UNITED STATES DEPARTMENT OF THE INTERIOR **BUREAU OF LAND MANAGEMENT**

SUNDRY NOTICES		N WELLS		MMLC064118	
Do not use this form for proposals to drill or to re-enter an abandoned well. Use Form 3160-3 (APD) for such proposals. SUBMIT IN TRIPLICATE - Other instructions on reverse side.				66. If Indian, Allottee or Tribe Name	
SUBMIT IN TRIPLICATE - Other instructions on reverse side				7. If Unit or Ca	A/Agreement, Name and/or N

1. Type of Well Gas Well Other WZW				8. Well Name and No. E.C. Hill D #1	
2. Name of Operator OXY USA Inc. 16696				Federal	, 11+ (
UXY USA Inc. 16696 3a. Address 3b. Phone No. (include area code)				9. API Well No	/
P.O. Box 50250 Midland, TX 79710 432-685-5717			rea coae)	30-025-1094

OXY USA Inc. - Proposed E.C. Hill D Federal #1 API No. 30-025-10947

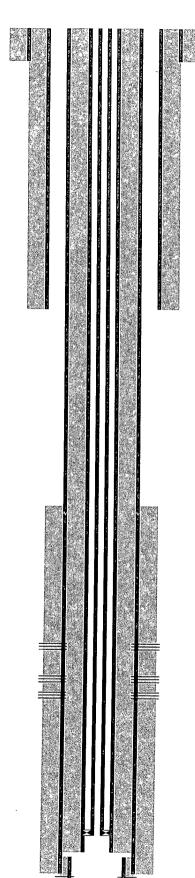
E.C. Hill D Federal #1 Well may be approved to be TA/SI for a period of 1 year or until 12/16/2011 after successful MIT and subsequent report with well bore diagram is submitted. This will be the only TA approval for this well. Well must be returned to production, beneficial use or plans to P&A must be submitted by December 16, 2011.
